BID ADDENDUM NO. 2

OWNER: EDGEMONT UNION FREE SCHOOL DISTRICT

PROJECT NAME: HIGH SCHOOL BUILDING 'A'
INTERIOR RENOVATIONS

DATE: October 28, 2025

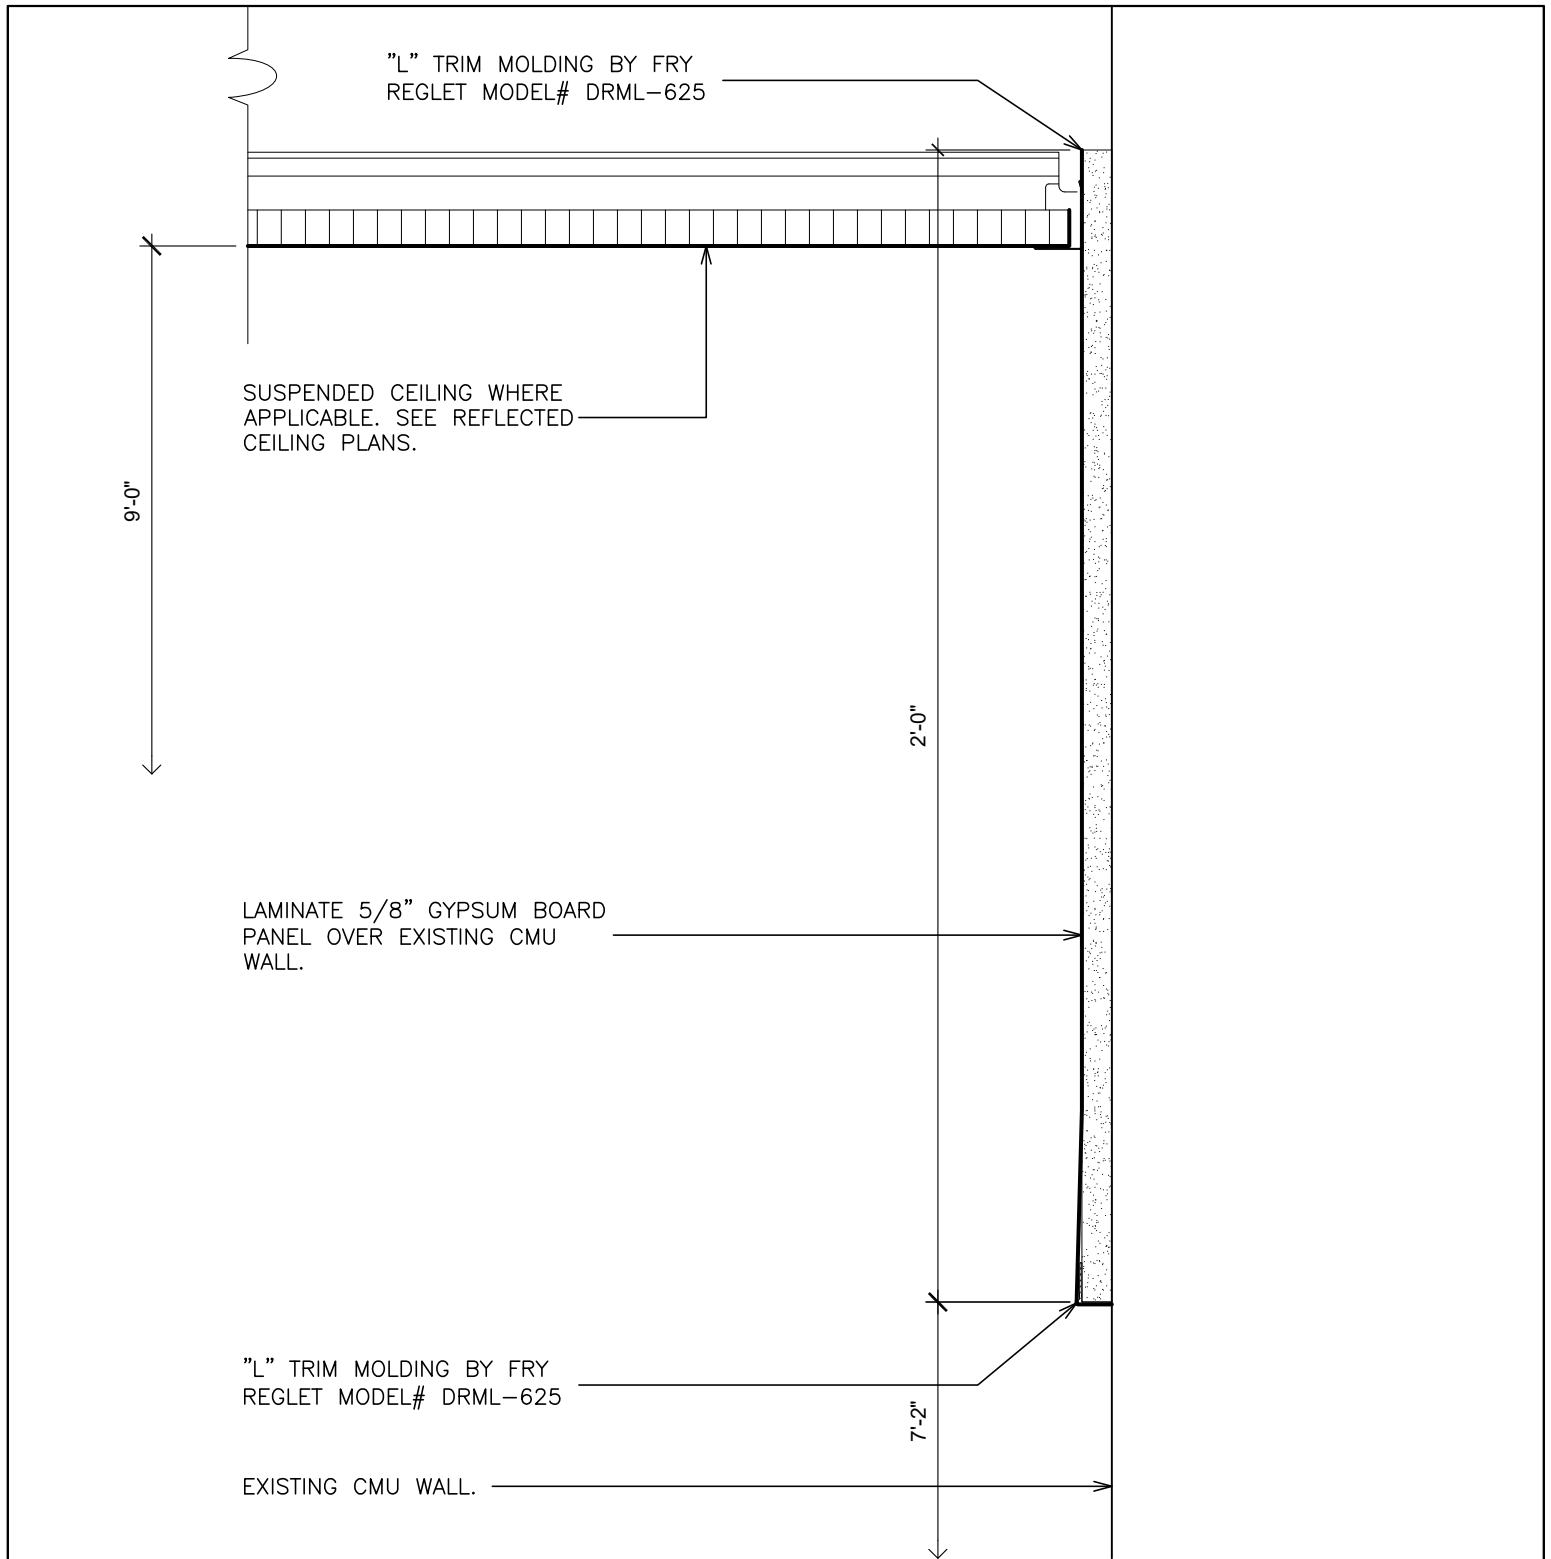
ADD laminated gypsum board wall covering in rooms 100, 101, 102, 103, 104, 119, 120, 121, 122, 123, & 124 as per Sketch SK-A1.2 attached to this addendum.

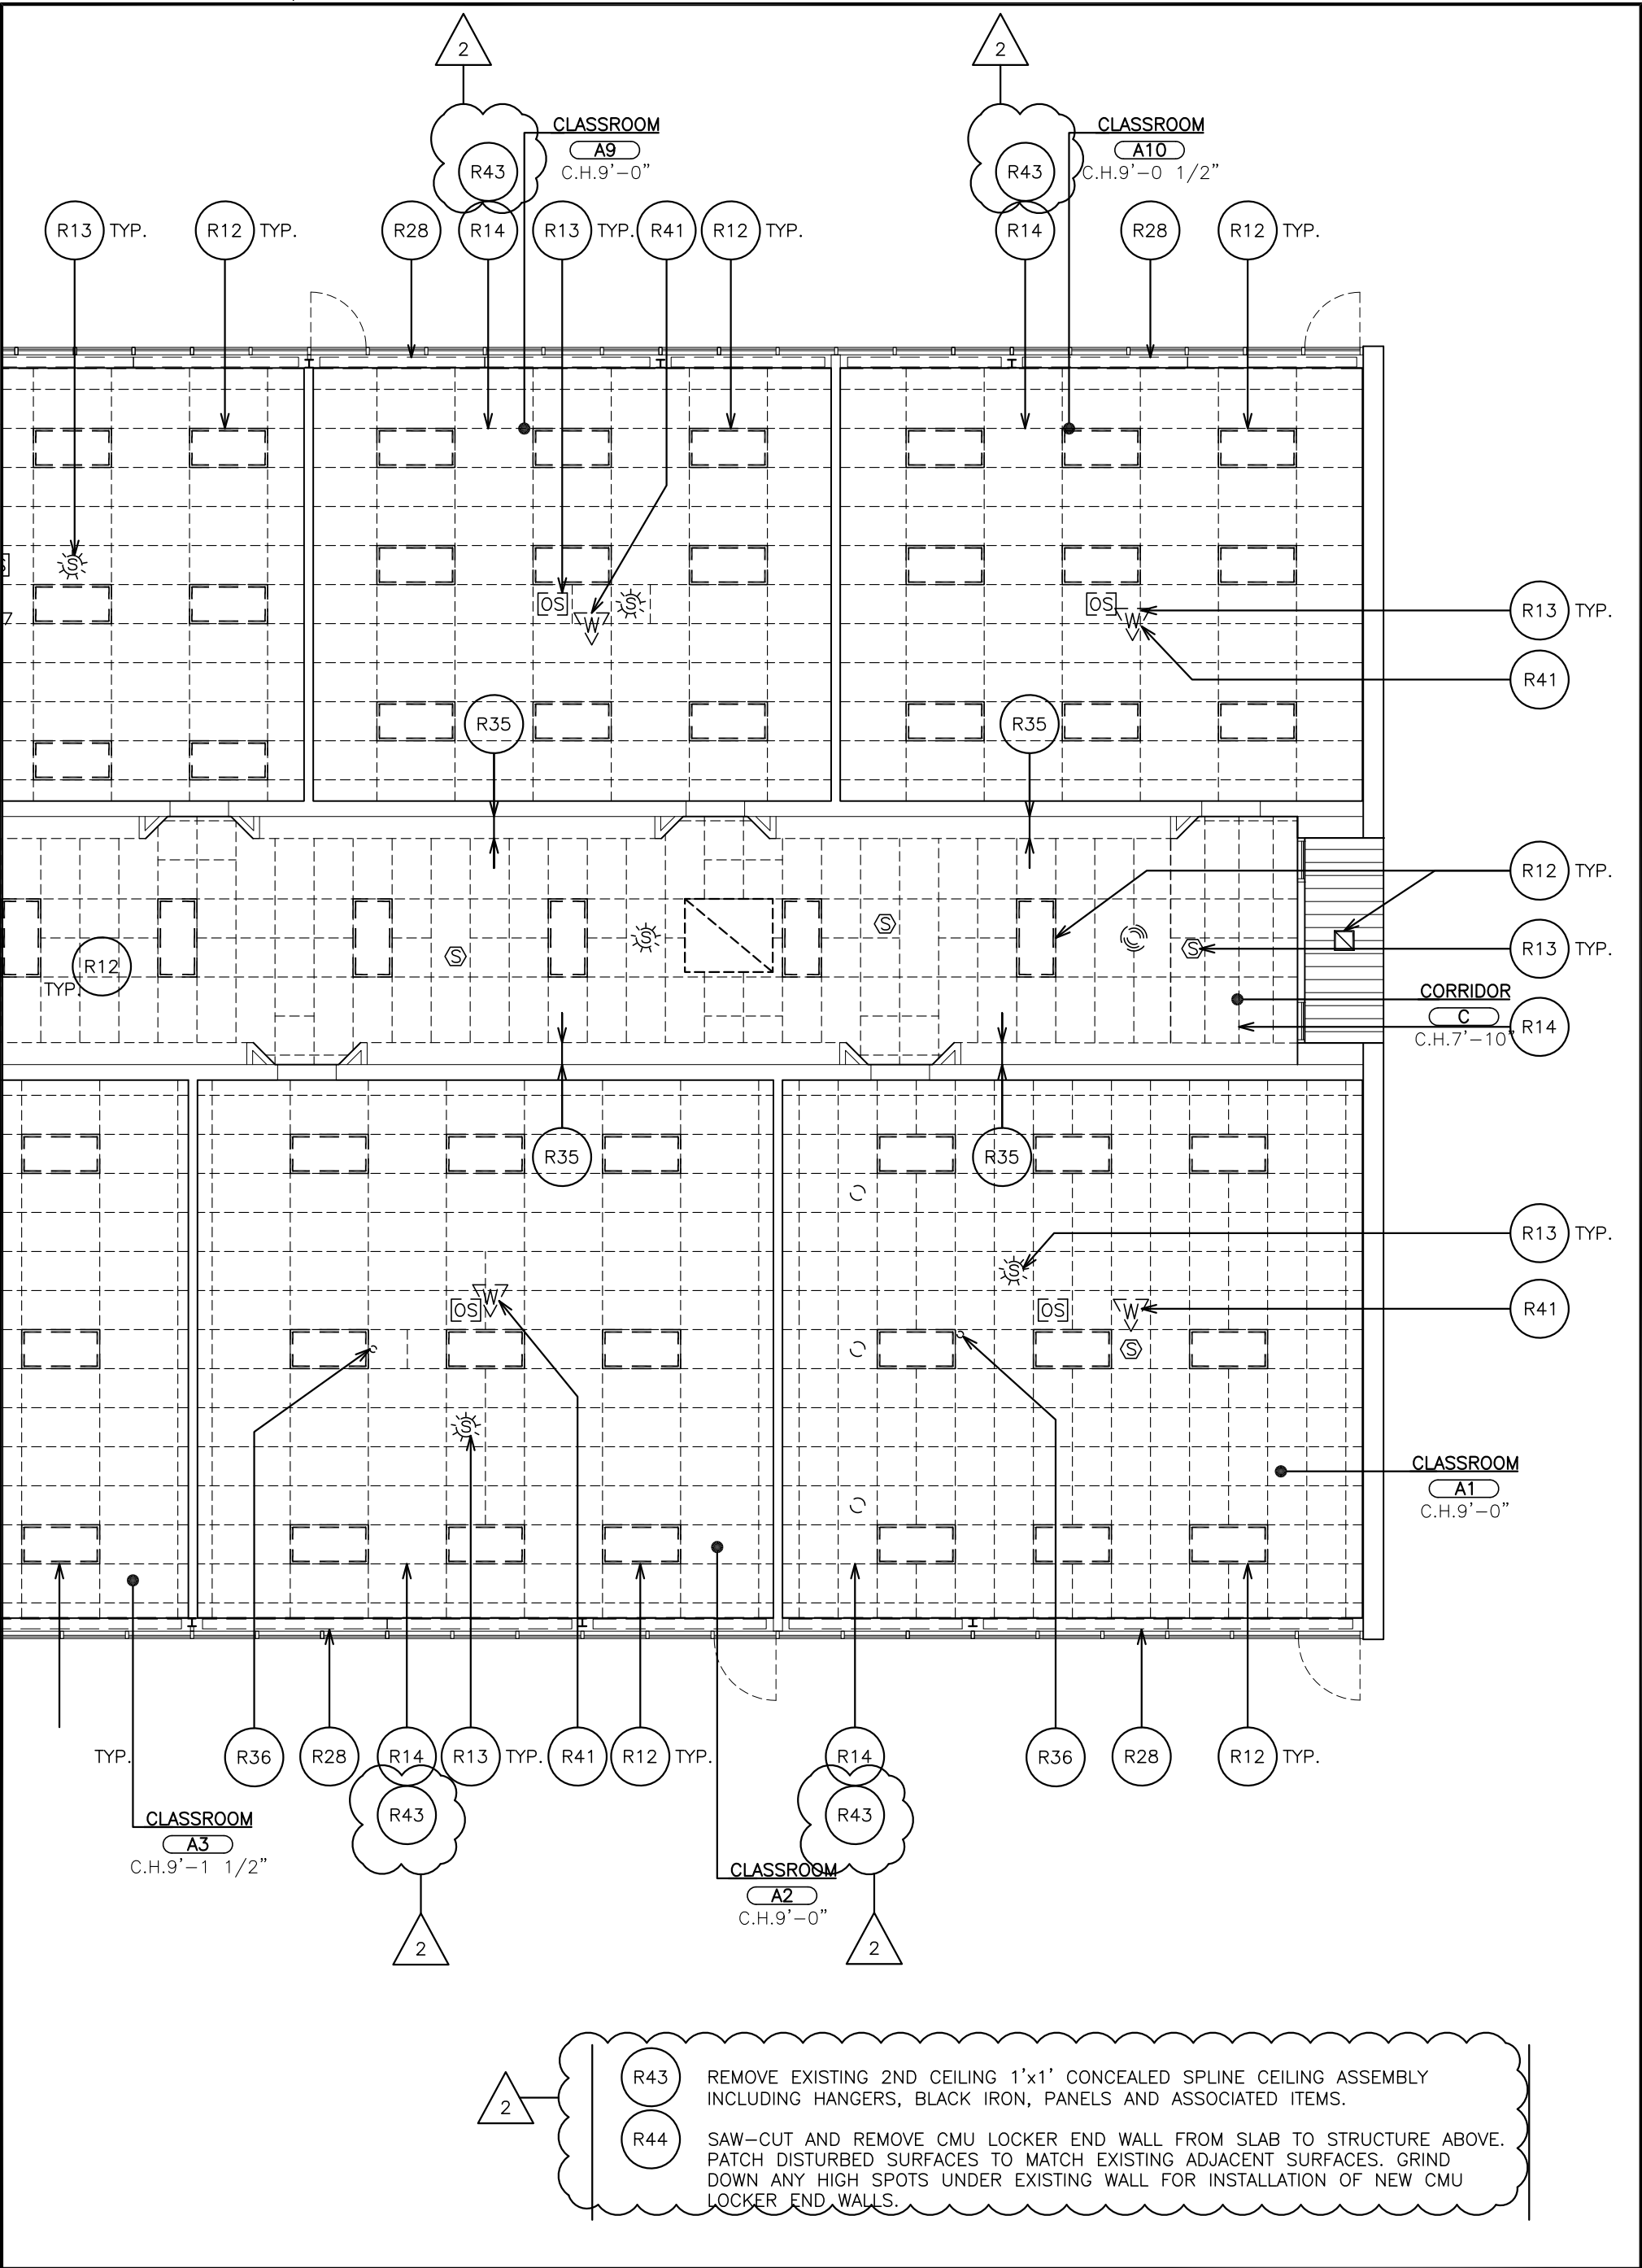
DRAWING AR200 – FIRST FLOOR REMOVAL REFLECTED CEILING PLAN

ADD Removal Note R43 "Remove existing 2nd ceiling 1'x1' concealed spline ceiling assembly including hangers, black iron, panels and associated items."

ADD Removal note R43 to rooms A1, A2, A9 & A10 as shown on Sketch SK-A1.3 attached to this addendum.

DRAWING TITLE
BOLLARD DETAIL
{REF. DWG HSA-ES200}

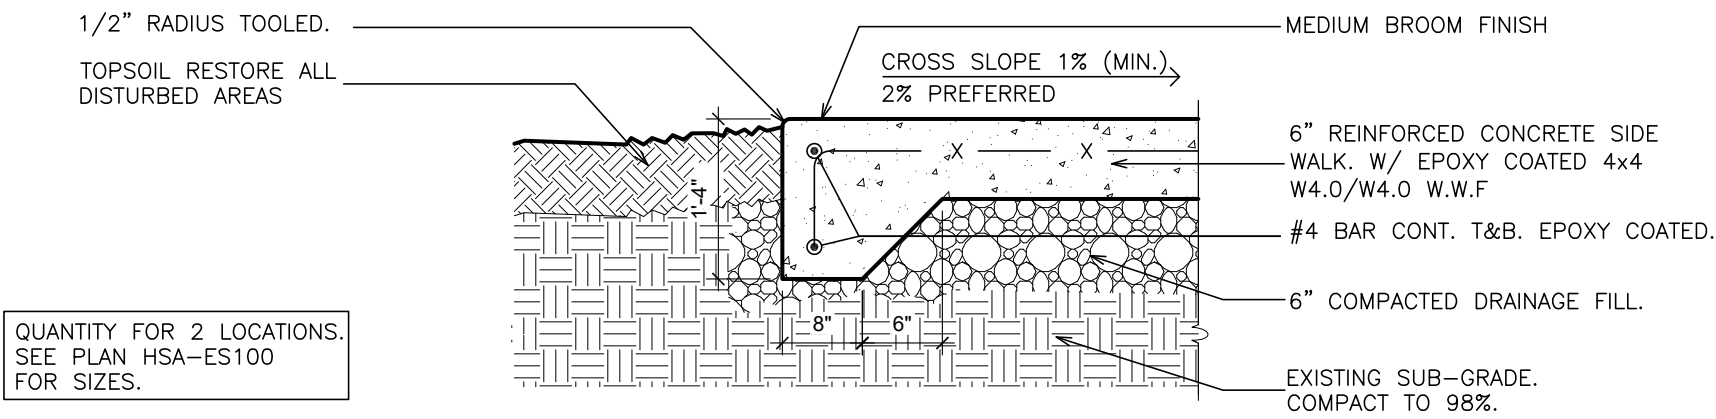
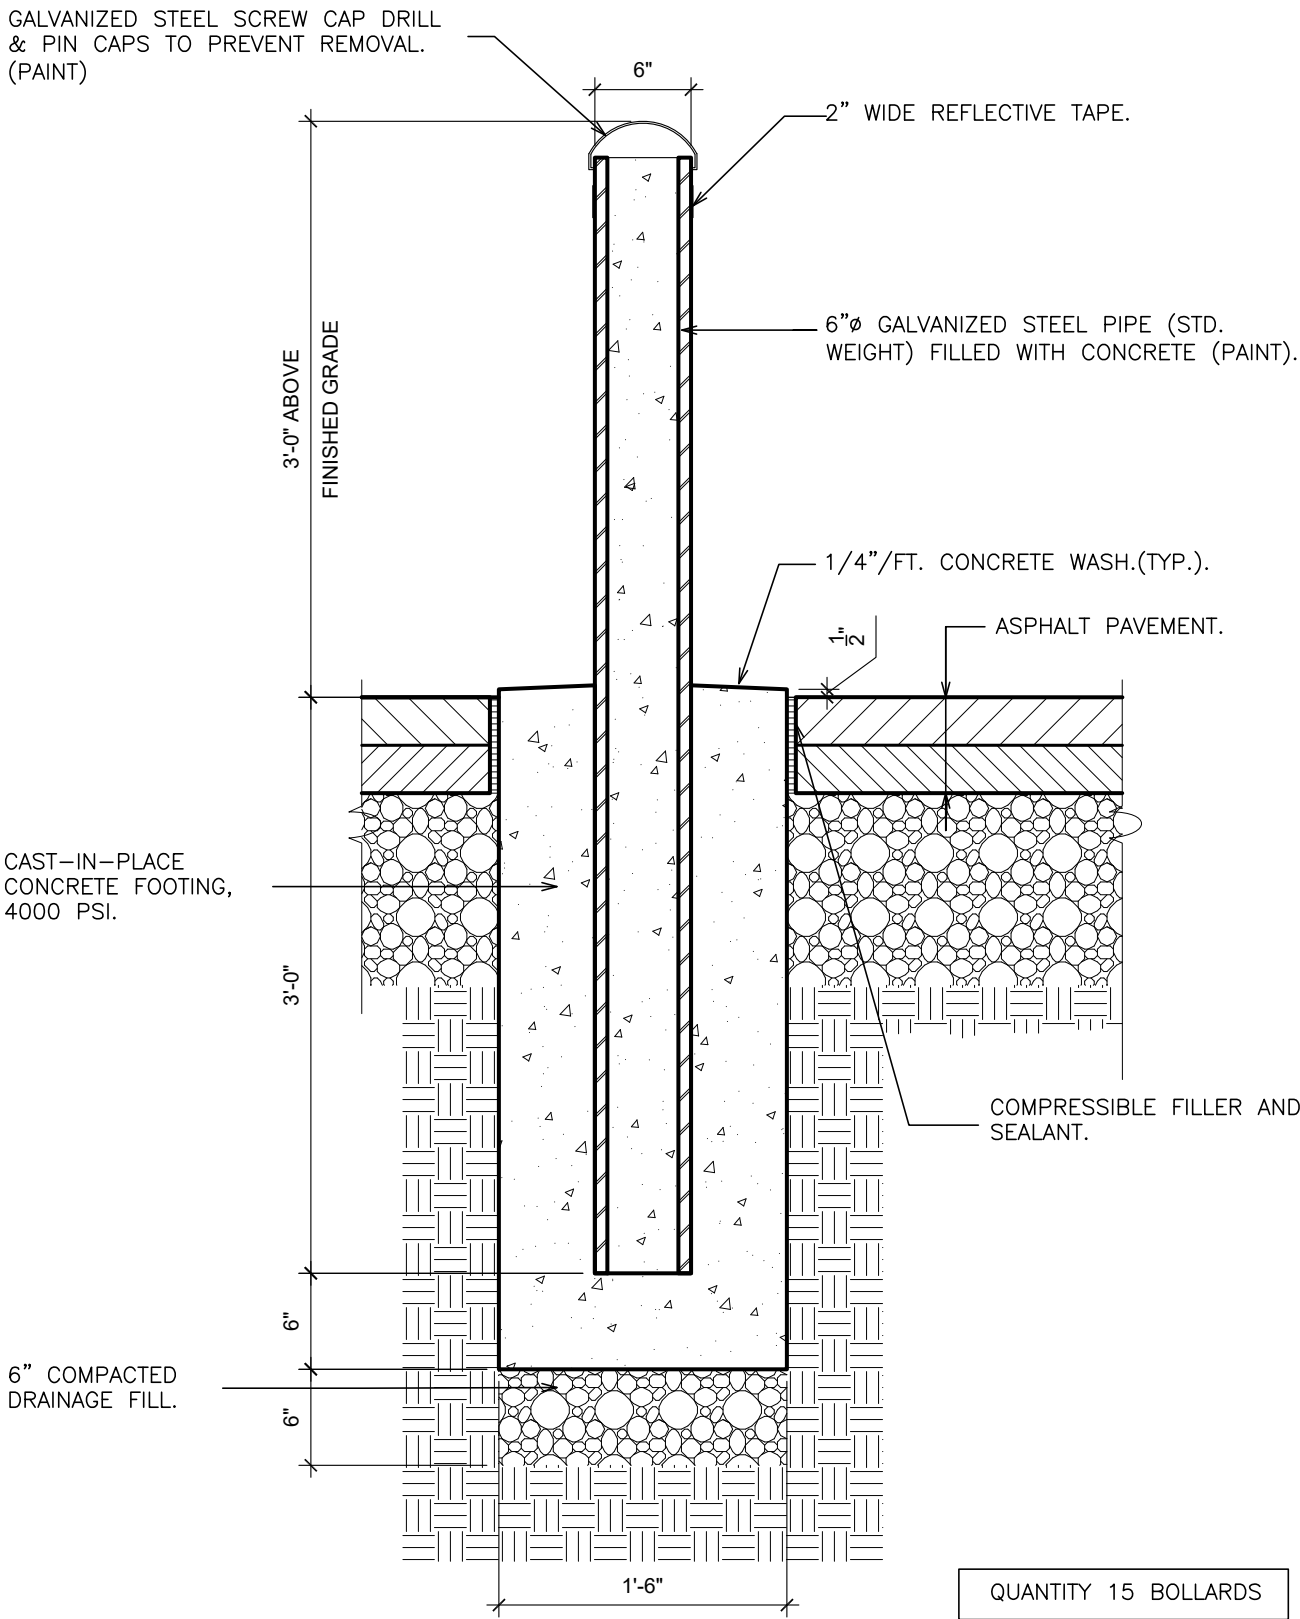
DRAWING HS-A ES200 – ELECTRICAL SITE TRENCH DETAILS

ADD Details 7 & 8 as shown on Sketch SK-E1.0 attached to this addendum.
